**PROPOSED MIXED-USE DEVELOPMENT**  
**254-260 FRANKLIN STREET, ADELAIDE**  
**TRAFFIC AND PARKING REPORT**

**PROPOSED MIXED-USE DEVELOPMENT  
254-260 FRANKLIN STREET, ADELAIDE (APP ID: 26000407)**

I refer to the proposed residential development at 254-260 Franklin Street, Adelaide. As requested, I have reviewed the Request for Information (RFI) received from the City of Adelaide (Council) and provide the following comments in respect to the traffic related queries. The key queries provided by the Council are quoted in italics below, followed by my response.

### DESIGN REVIEW - GROUND FLOOR

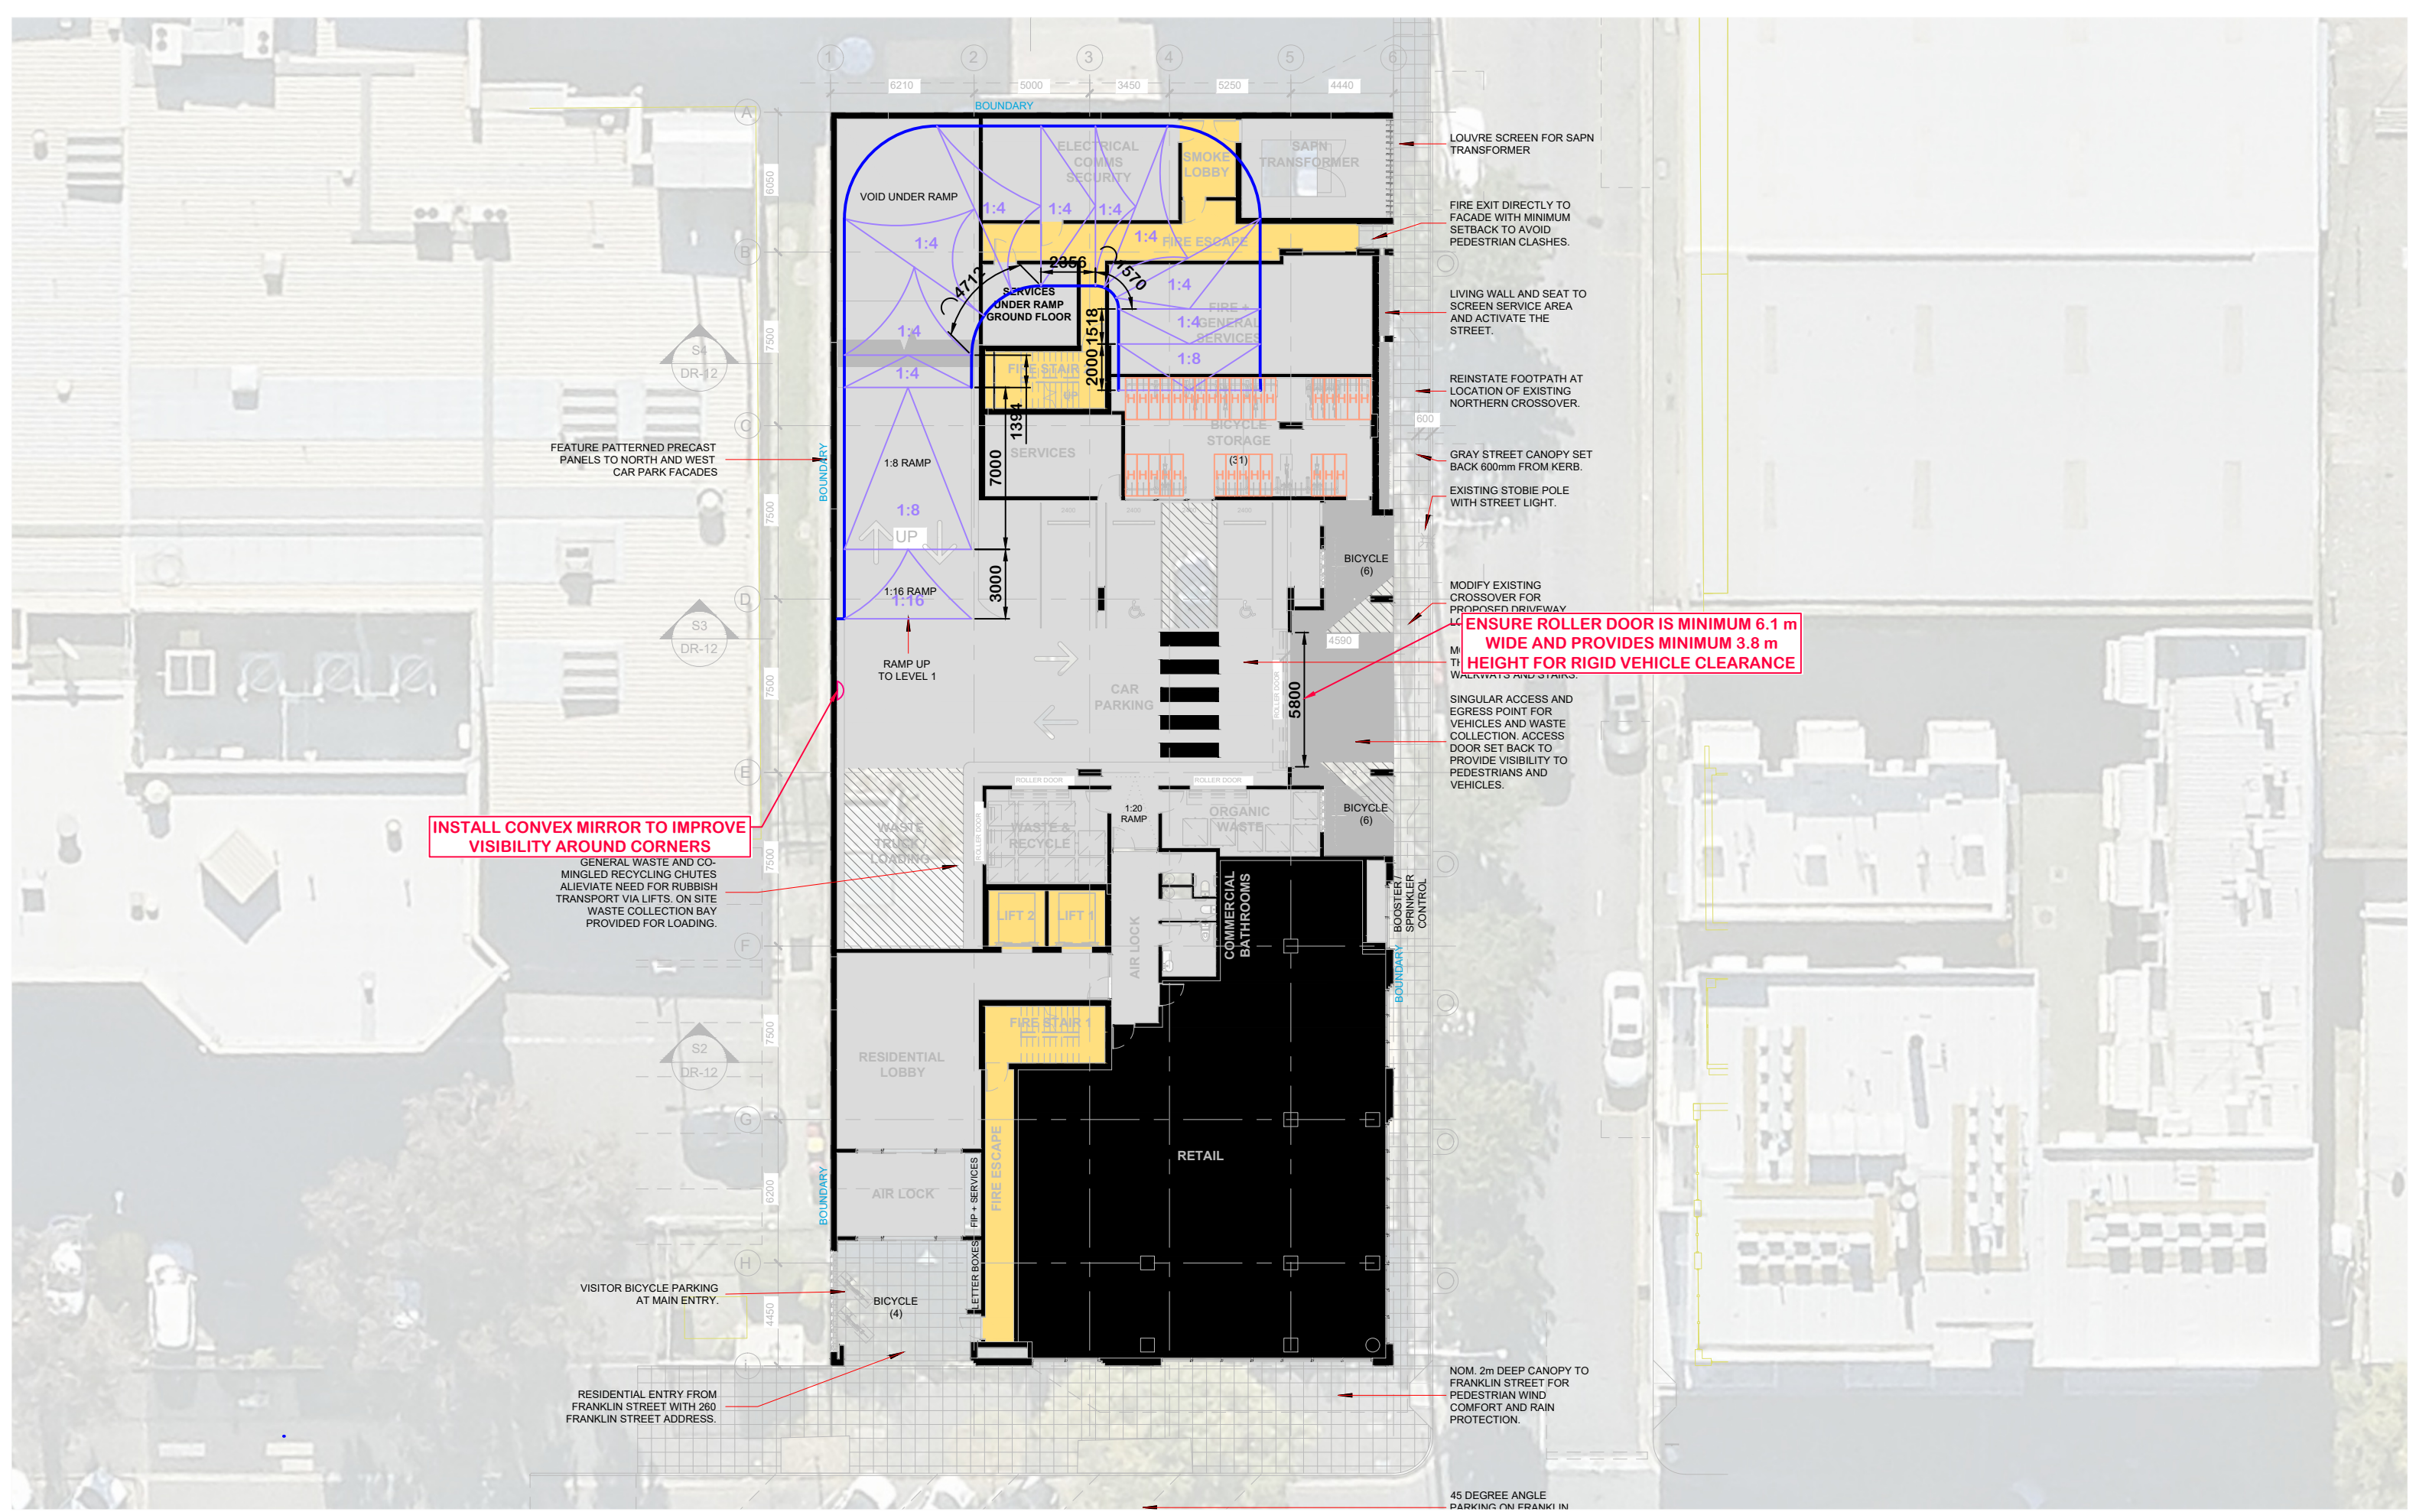
**INSTALL CONVEX MIRROR TO IMPROVE VISIBILITY AROUND CORNERS**  
 GENERAL WASTE AND COMINGLED RECYCLING CHUTES ALLEVIATE NEED FOR RUBBISH TRANSPORT VIA LIFTS. ON SITE WASTE COLLECTION BAY PROVIDED FOR LOADING.

**ENSURE ROLLER DOOR IS MINIMUM 6.1 m WIDE AND PROVIDES MINIMUM 3.8 m HEIGHT FOR RIGID VEHICLE CLEARANCE**

**PROPOSED RESIDENTIAL DEVELOPMENT**  
 254-260 FRANKLIN STREET, ADELAIDE  
 DESIGN REVIEW - GROUND FLOOR DESIGN COMMENTS  
 PROJECT # 25211 SHEET # 01\_SH02

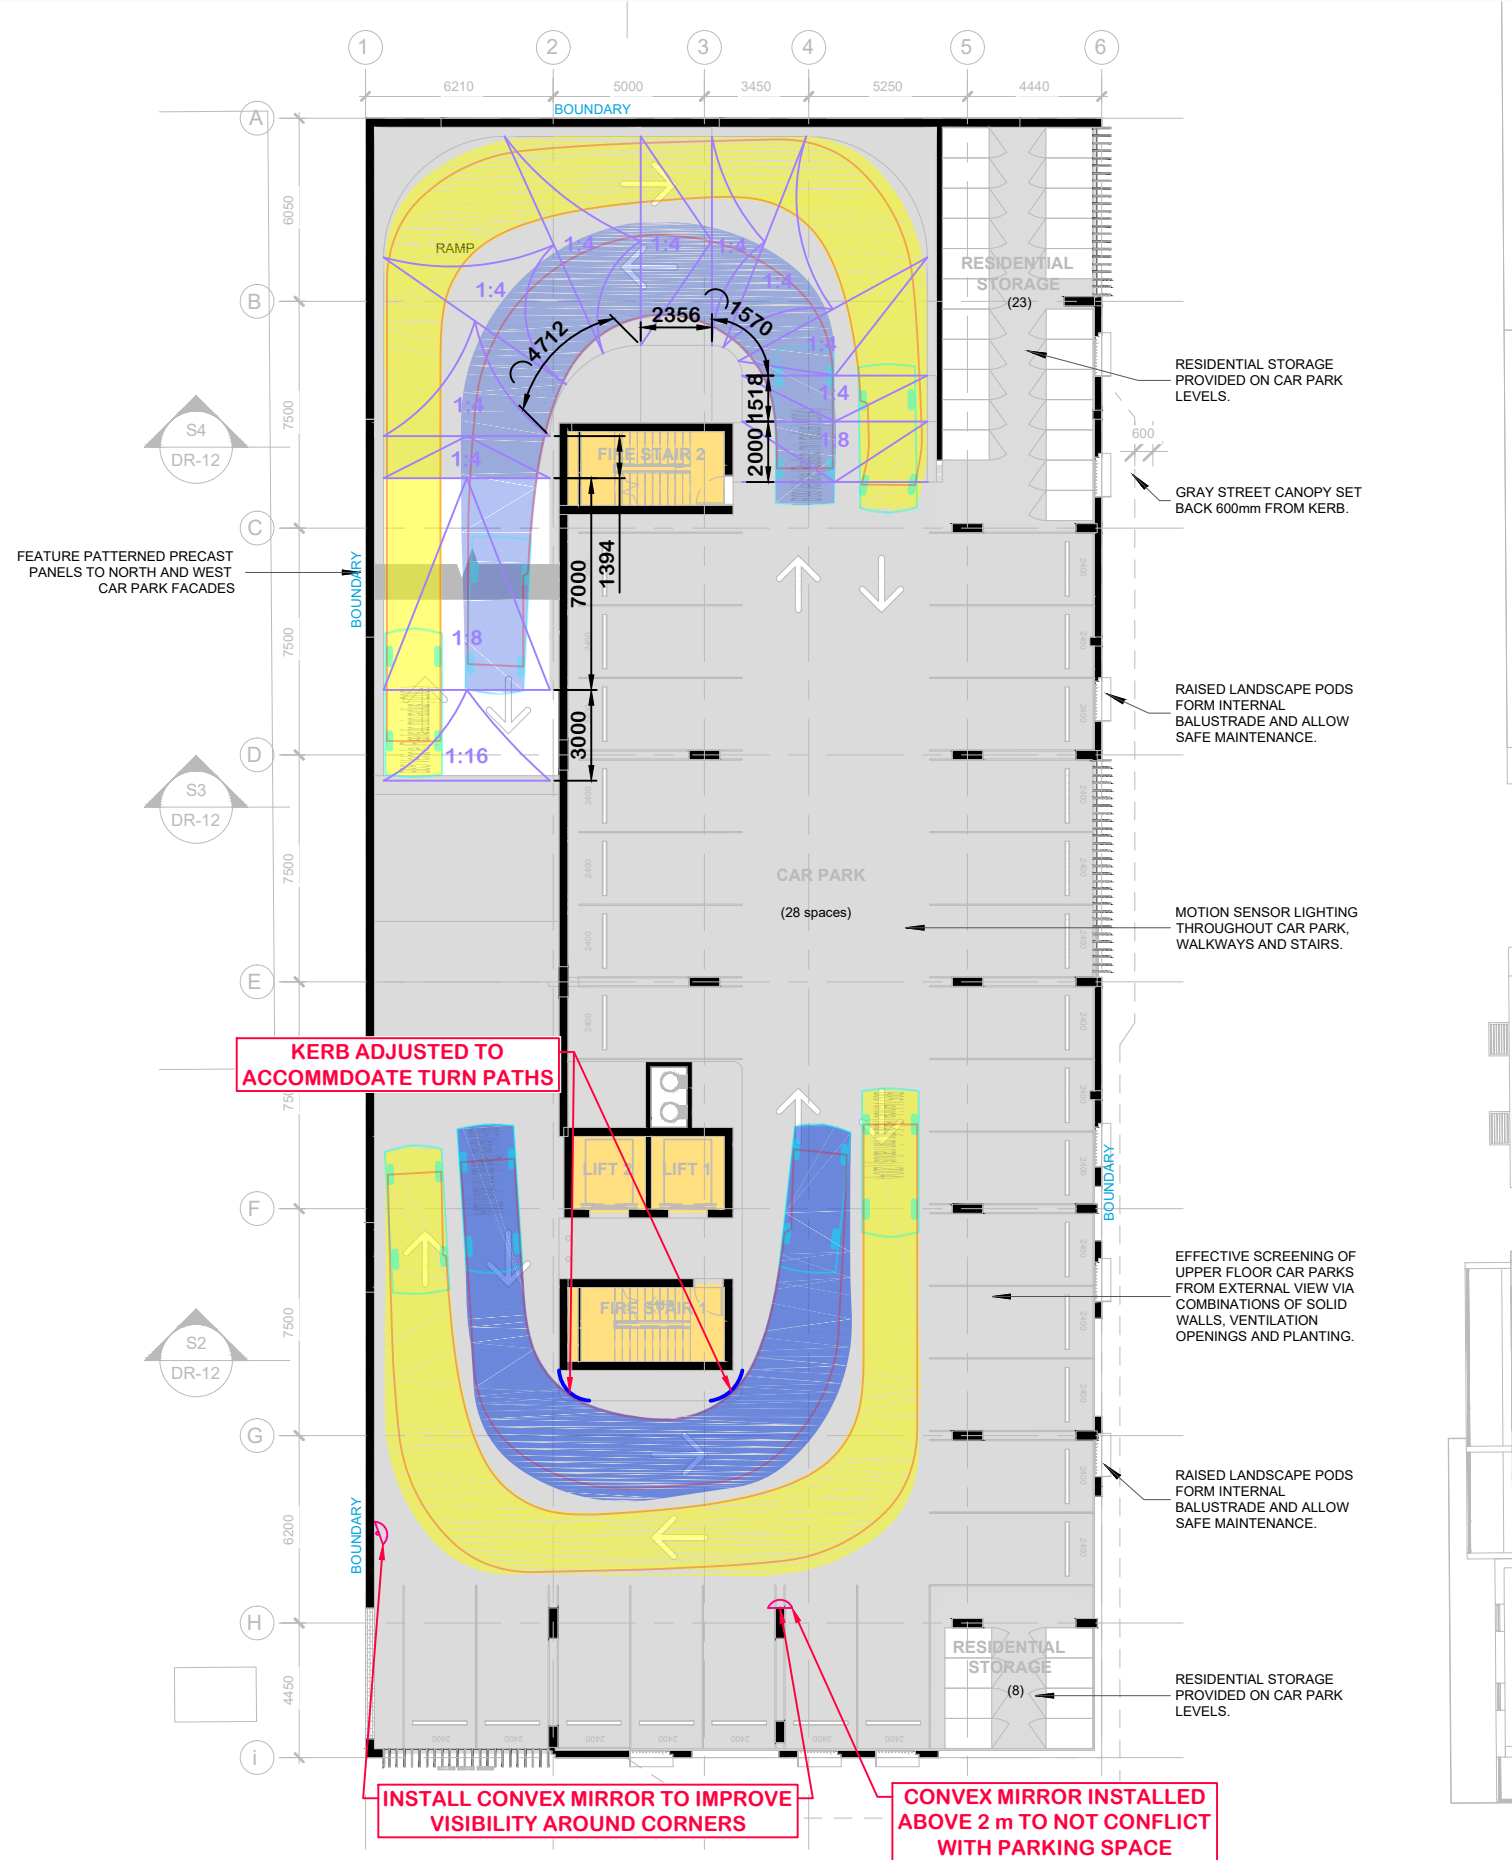
*"The turning circle template for vehicles going up the ramp appear to interfere with a truck sitting in waste area and I would like a response from a suitably qualified person regarding the convenience of movements within the site when waste is being collected and how the operations will be managed."*

There is a minor encroachment to the circulation roadway when a waste vehicle is located in the loading area. The internal circulation driveway will narrow to approximately 5.3 m wide with a vehicle stored in the loading zone. The distance between passing opportunities is approximately 13 m metres which is well within the acceptable limit for one-way width circulation roads accommodating two-way movements identified by Australia/New Zealand Standard for "Parking Facilities Part 1: Off-street car parking". It is also noted that volumes will be less than the level of 30 peak hour movements, above which the Standard recommends two-way passing provisions along the full length of a circulation road/driveway.

Regardless, it is anticipated that waste collection will be undertaken outside of peak periods (i.e. light vehicle movements will be significantly less than peak hour volumes). A convex mirror is proposed to be placed along the wall adjacent the loading zone to assist intervisibility between drivers along the circulation driveway. As such, it is anticipated that a waste vehicle located in the loading zone will be appropriately accommodated without resulting in the unsafe operation of the site's internal circulation aisles.

*Figure 1 – Pedestrian sightline availability when exiting from the site.*

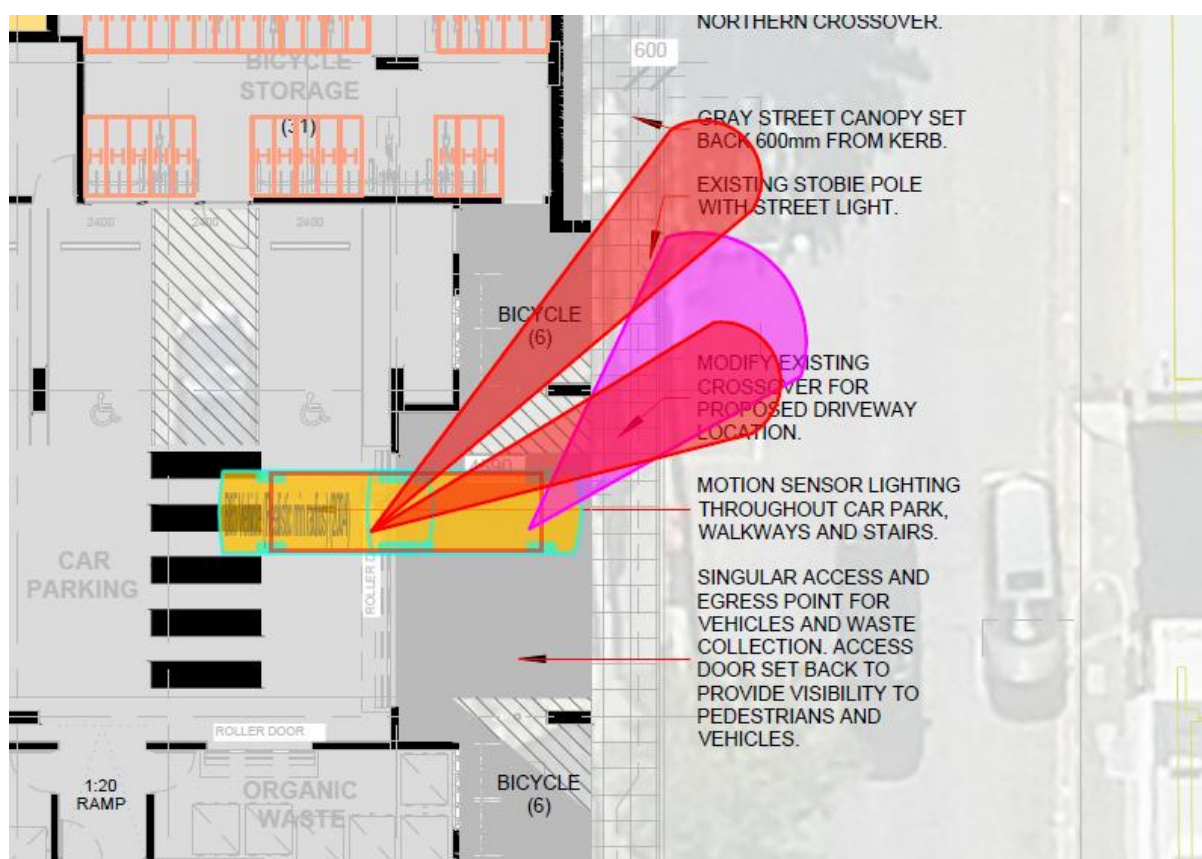
*"Vehicular access should provide clear sight lines to pedestrians in accordance with the requirement of Clause 3.2.4(b) of AS/NZS 2890.1-2004 - Figure 3.3."*

Adequate sight line provisions are provided at the access, notwithstanding a column within the sight distance triangle stipulated by AS/NZS 2890.1:2004. Specifically, despite the position of the column, there will be adequate intervisibility between a driver exiting the site and a pedestrian on the pathway adjacent the subject site.

Operationally, as a driver exits the site, the sightline provision shifts as they move forward which will provide opportunities to observe a pedestrian around the column (refer Figure 1 below). Furthermore, a pedestrian on the adjacent pathway will also have sight of the vehicle body around the column.

As illustrated in Figure 1, as a driver moves forward whilst exiting the site, visibility will be able to be established along the site's frontage in a similar manner to that desired by the pedestrian sightline requirements of AS/NZS 2890.1:2004. It is therefore considered that the intent of the standard is achieved by the site's design and that the access will maintain the safe operation of the adjacent pedestrian footpath.
